**RE: RESPONSE TO INFORMATION REQUEST IN RELATION TO AN APPLICATION FOR MATERIAL CHANGE OF USE FOR FOUR (4) MULTIPLE DWELLINGS AND / OR SHORT-TERM ACCOMMODATION, SHOP, OFFICE, FOOD AND DRINK OUTLET (NOT PROVIDING A DRIVE-THROUGH FACILITY) AND HEALTH CARE SERVICES AND RECONFIGURATION OF A LOT (2 INTO 5 LOTS AND COMMON PROPERTY)**

### **30-32 Warner Street, Port Douglas Council Information Request Response**

ROOF LAY-OUT PLAN - LEVEL 2  
1 : 100

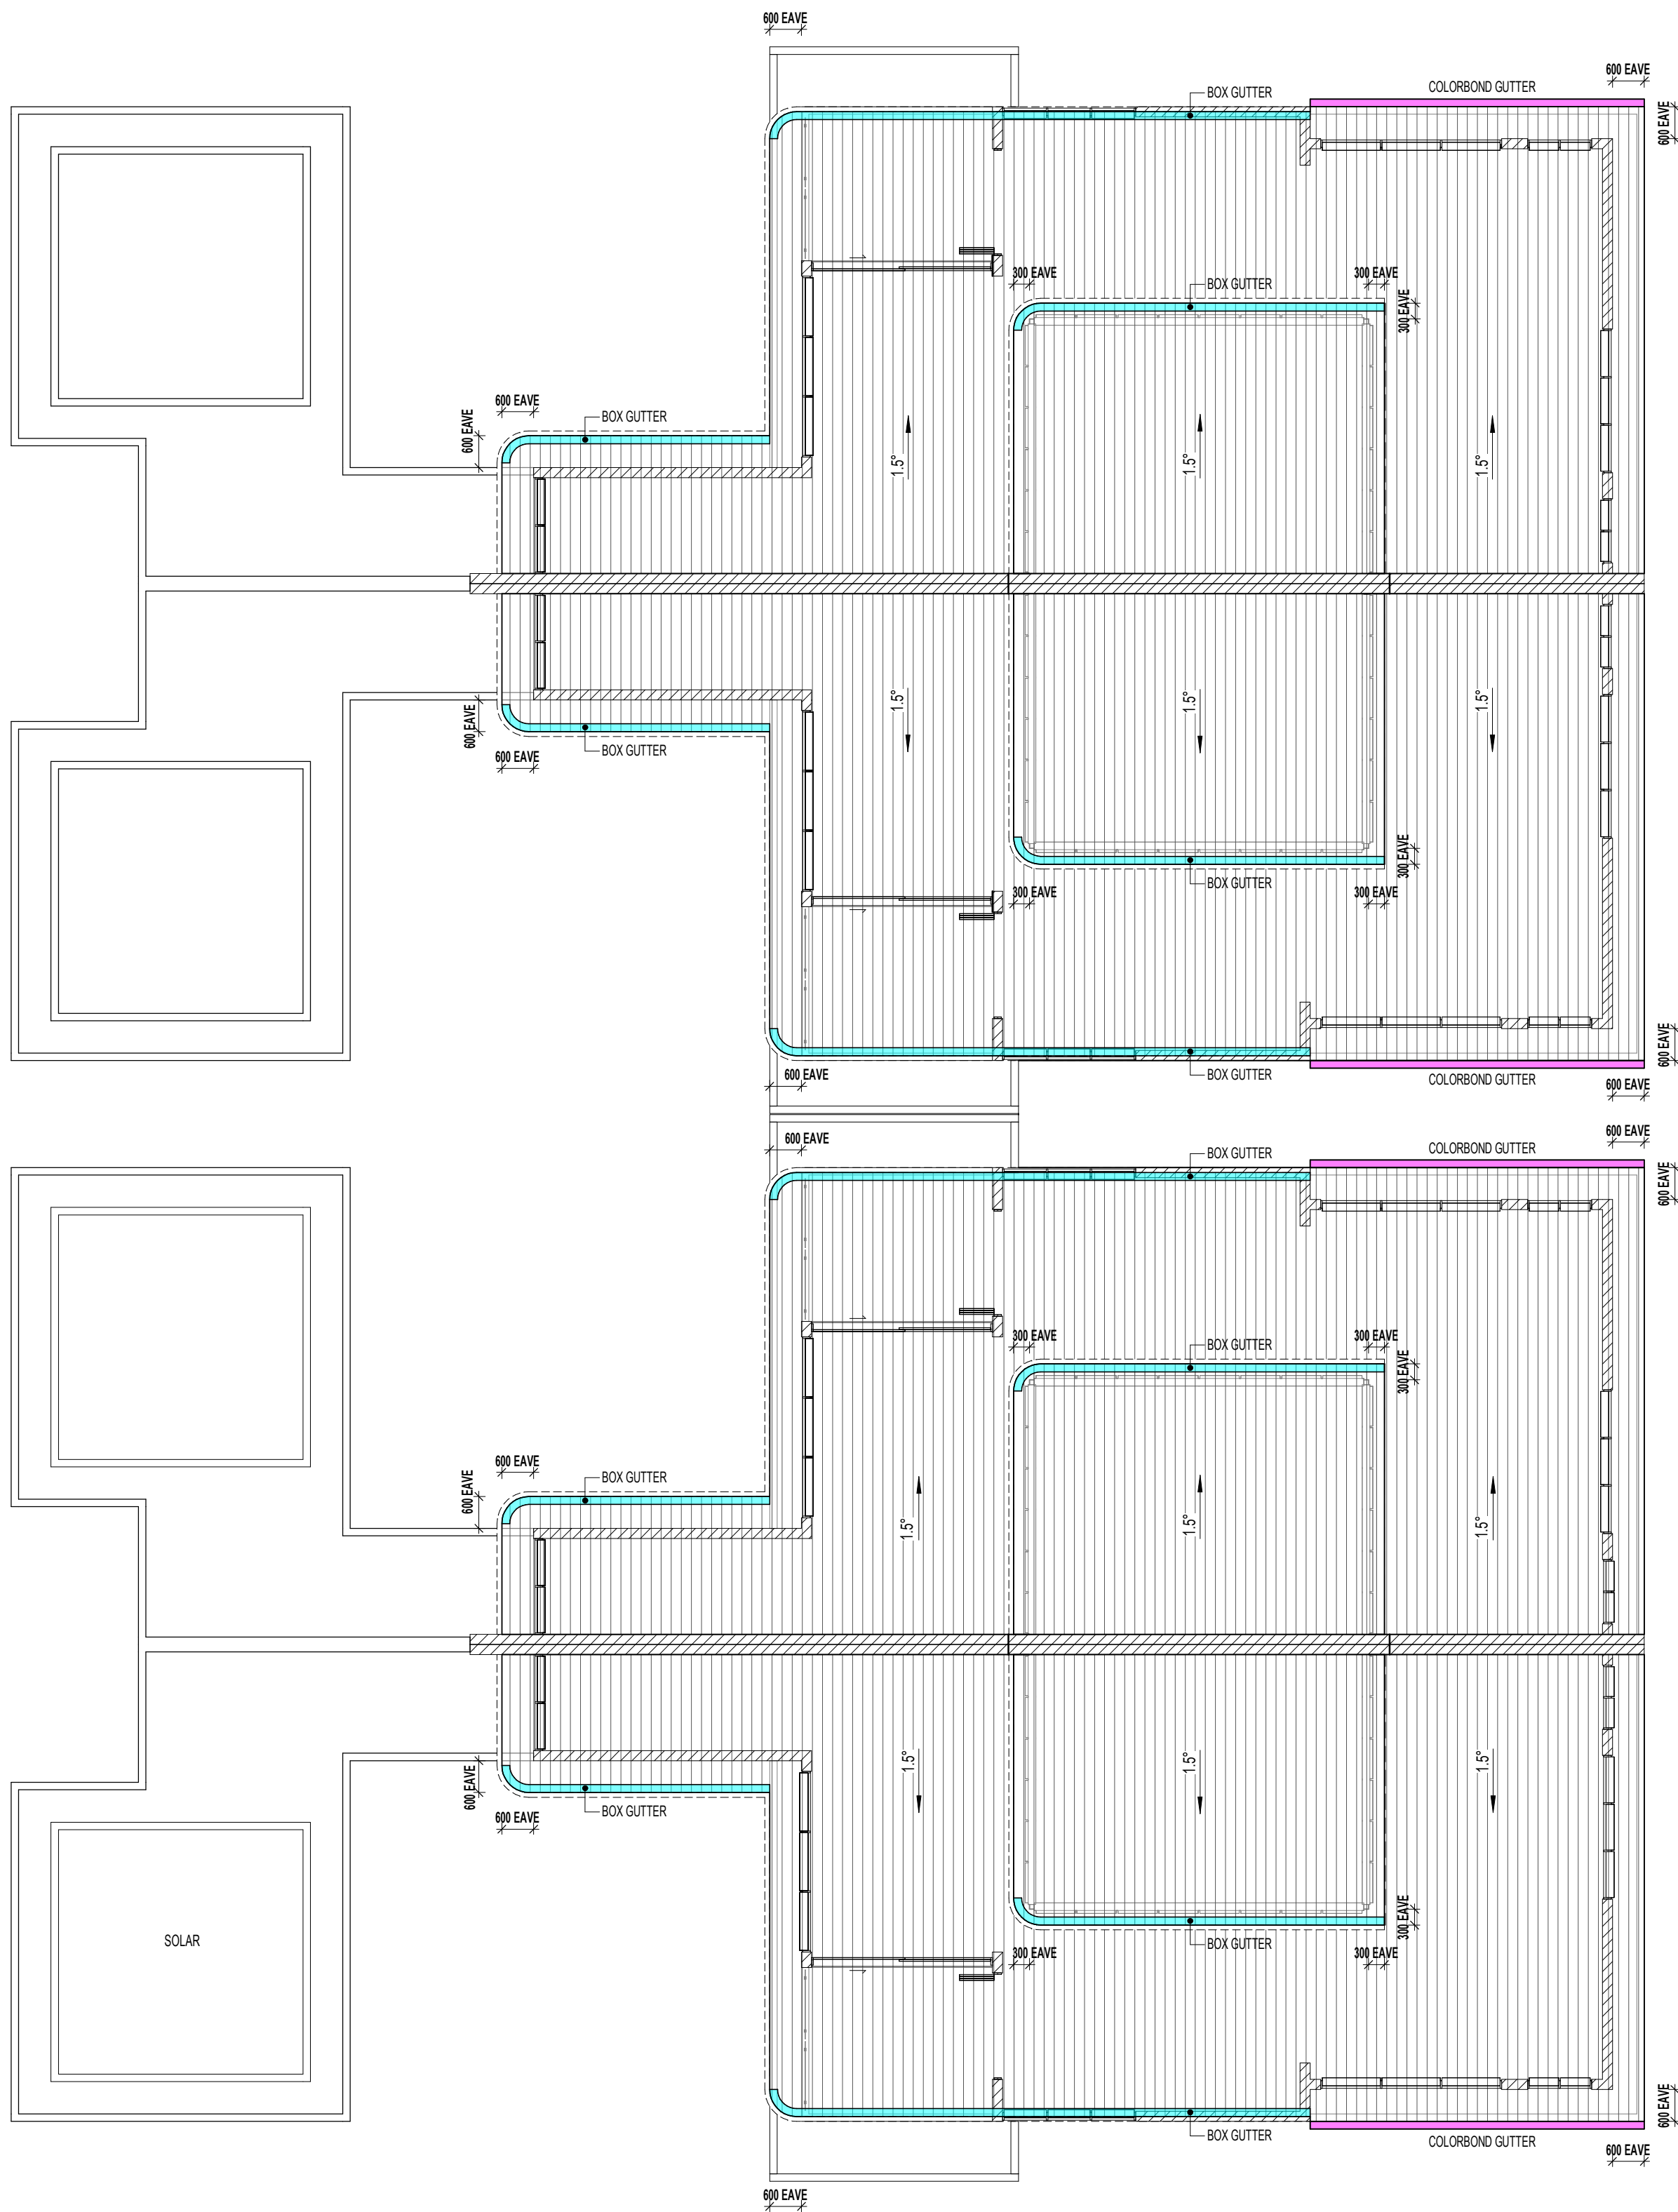
**5. Please provide a roof plan or clarify this attribute on the upper levels of the unit development. Council is wanting to ensure the window openings have suitable weather protection to enable the windows to be opened and gain air flow during rain events in the wet season.**

**Figure 1.**

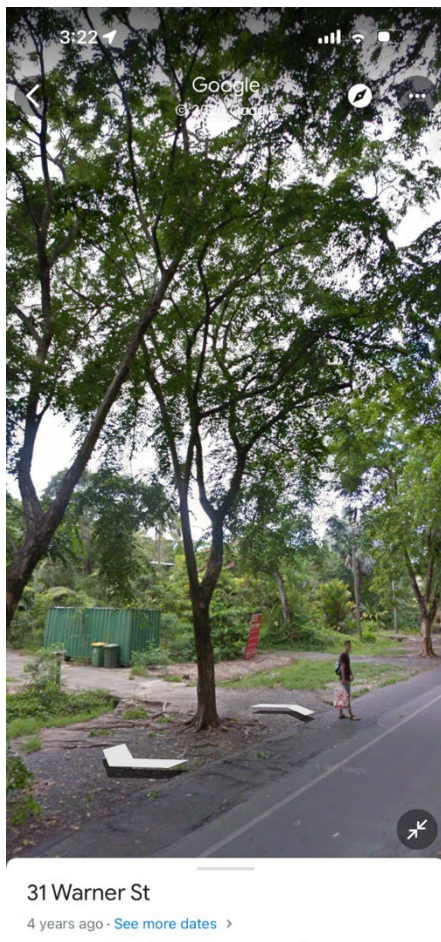
**Comments:** This tree has been severely cut beyond Australian Standards under the direction of Douglas Shire council Head Arborist, Jim Scott, as they had a severe issue with the trees dying due to suspected poisoning. Crews were asked to cut back to live wood, not growth points, to try mitigate the severity of the cuts. Please see pictures below of what the tree previously looked like using google street view. Figure 1.

Epicormic Growth is evident even at the lower trunk level which shows that the tree has been under stress and this growth, as it will be growing out from the bark initially will be weaker growth and there is powerlines nearby.

**Recommendation Comments:** Remove and stump grind. Trees could be replaced with same species to tie in with the surrounding streetscape and be a better option than persevering with trees in decline that will need to be removed and replaced in the future. This tree will not regain its vitality and vigour to grow into a suitable, safe tree for this streetscape.

Figure 2.

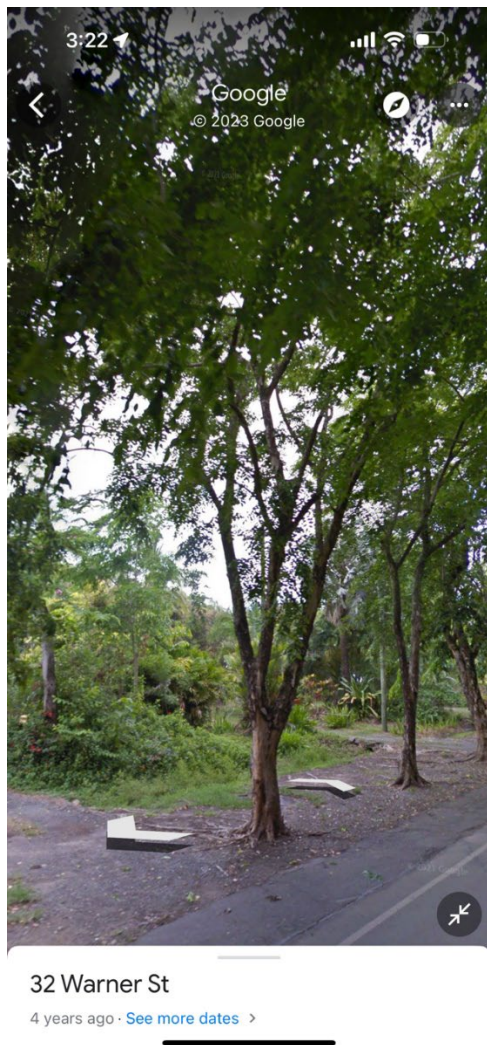
**Comments:** This tree has been severely cut beyond Australian Standards under the direction of Douglas Shire council Head Arborist, Jim Scott, as they had a severe issue due to suspected poisoning. Crews were asked to cut back to live wood, not growth points, to try mitigate the severity of the cuts. This has left large leaders as you can see in the photos below, dying back and bark continuing to peel off the whole way down the tree. Note in the picture below the heavy die back on lead branch. Please see pictures below of what the tree previously looked like using google street view. Figure 2.

Epicormic Growth is evident even at the lower trunk level which shows that the tree has been under stress and this growth, as it will be growing out from the bark initially will be weaker growth and there is powerlines nearby.

**Recommendation Comments:** Remove and stump grind. Trees could be replaced with same species to as tie in with the surrounding streetscape and be a better option then persevering with trees in decline that will need to be removed and replaced in the future. This tree will not regain its vitality and vigour to grow into a suitable, safe tree for this streetscape.

Landscape concept plan - Ground floor 1:100 @ A1

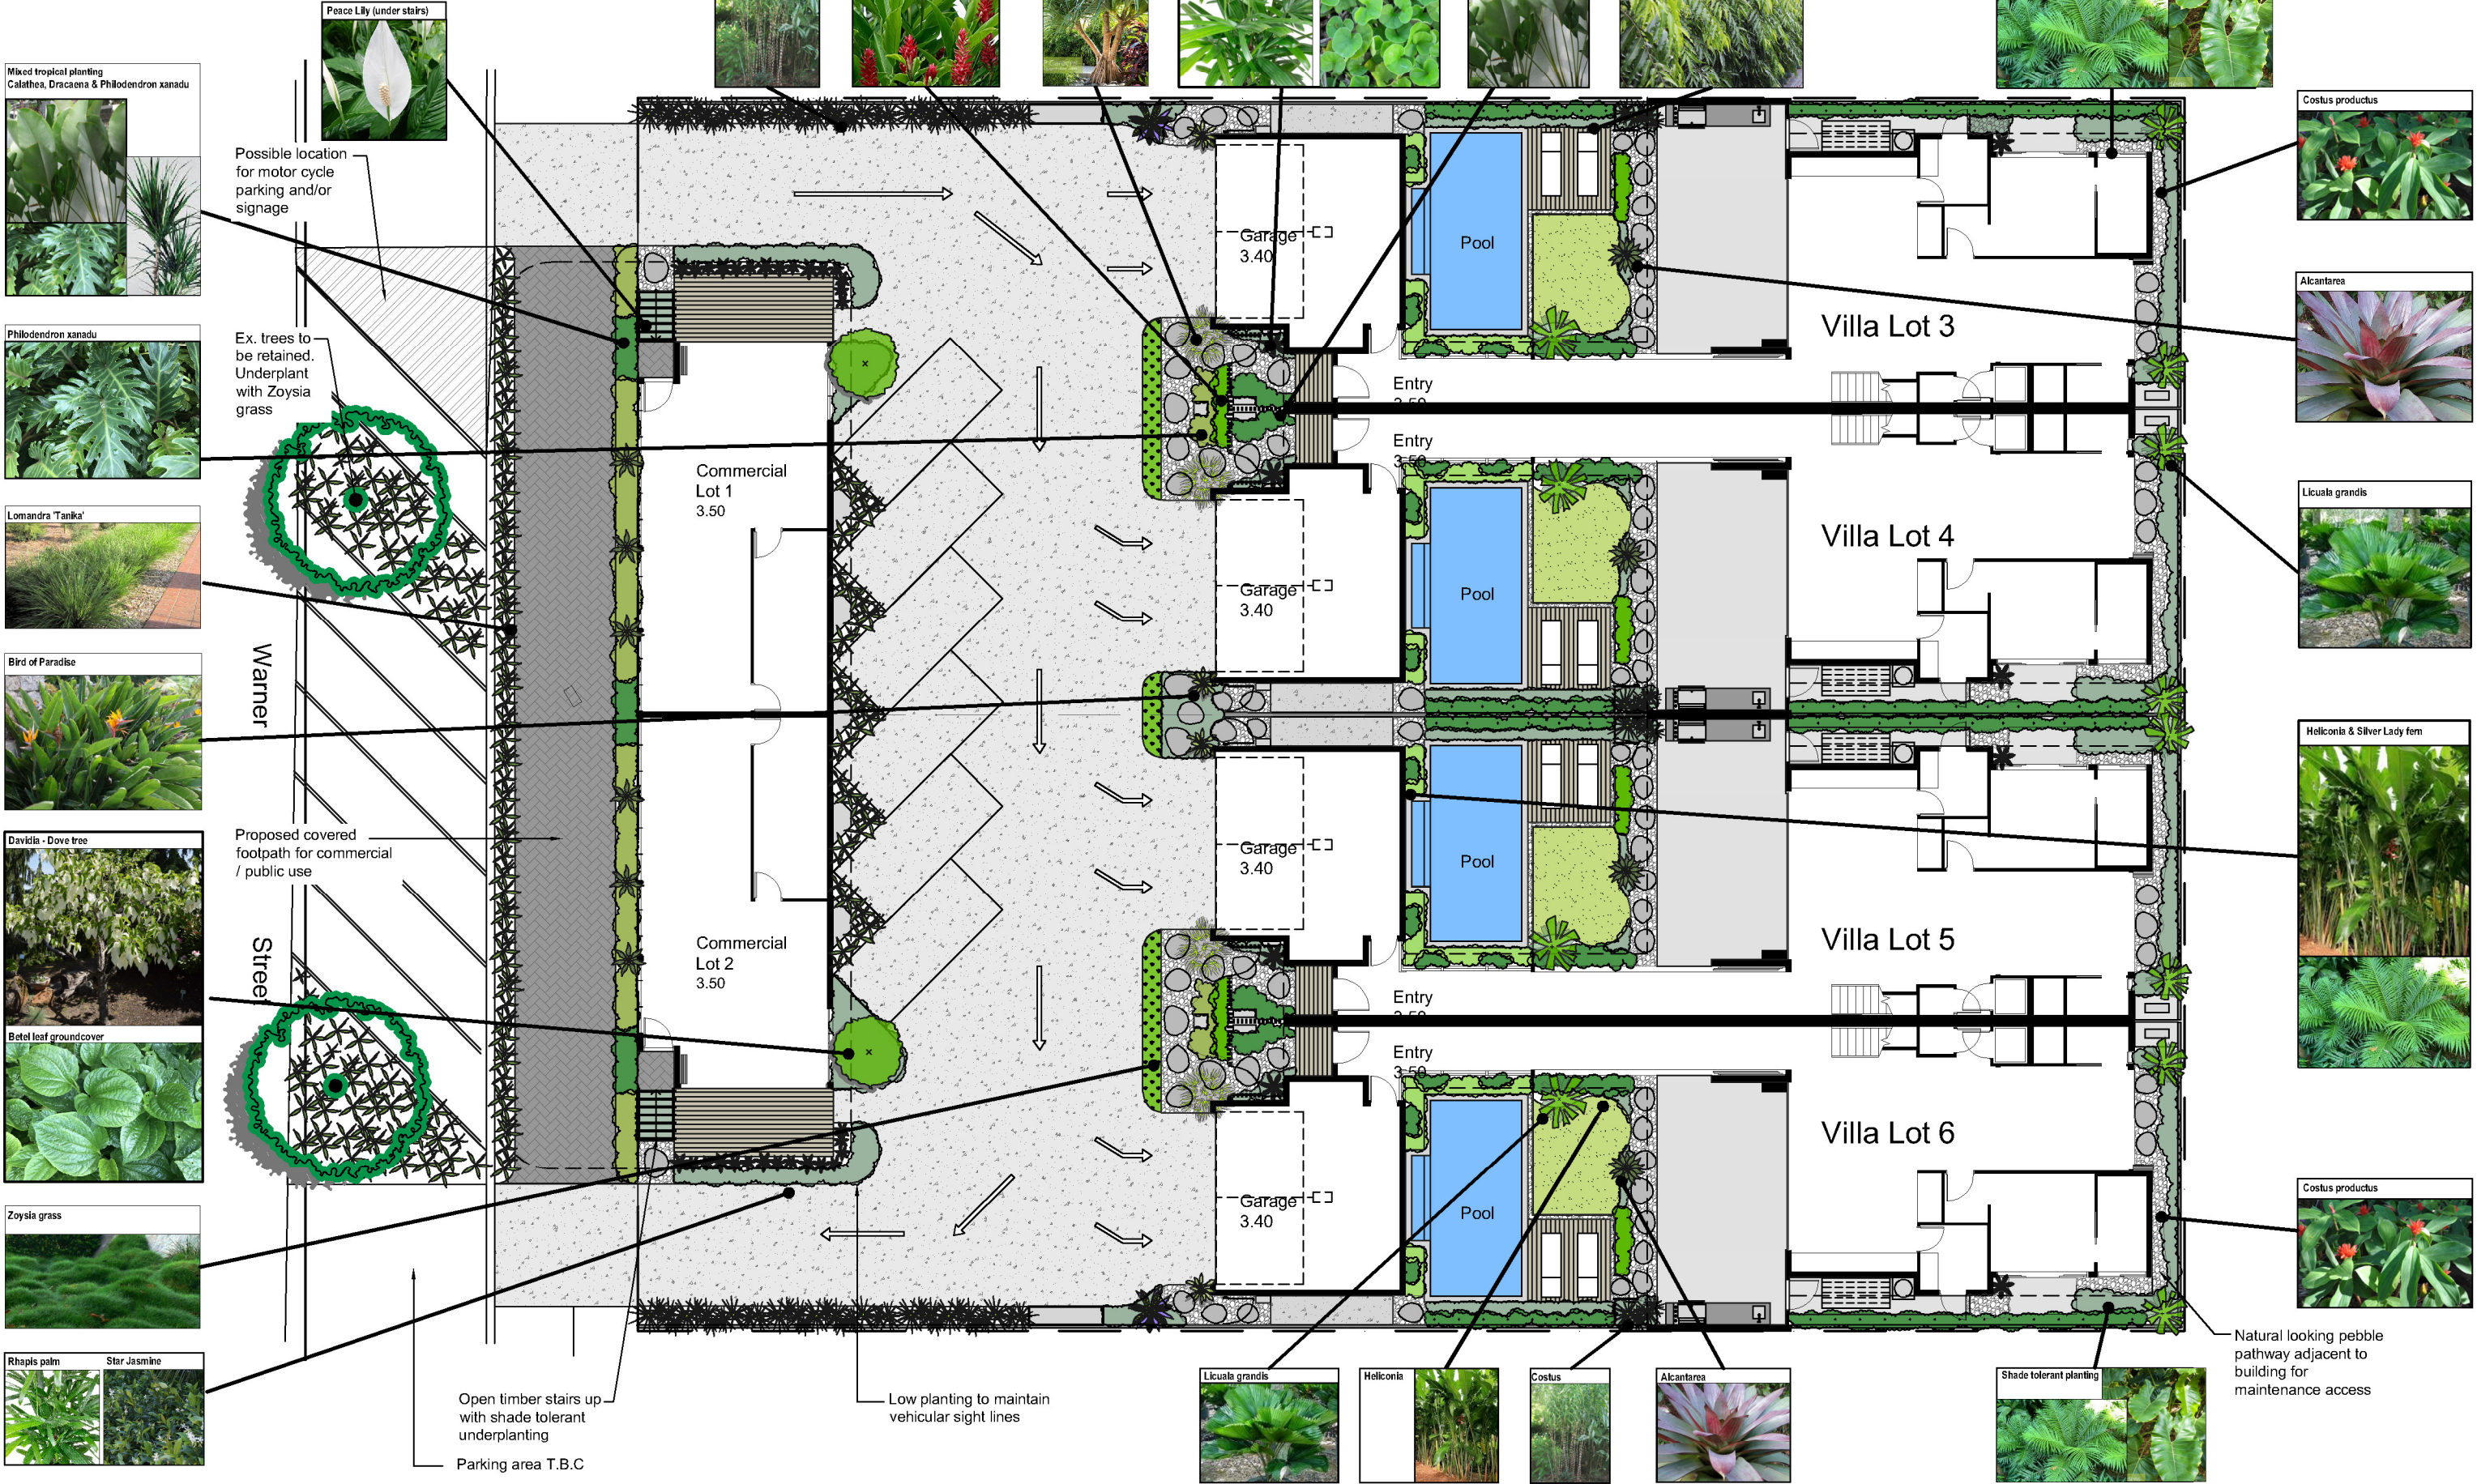
**6. Please provide a detailed landscape plan that incorporates tropical design and meets the Planning Scheme outcomes. Please advise how maintenance access is gained to the roof garden areas, including that for the commercial premises.**

Please see attached Landscape Plans included as **Annexure 4**.
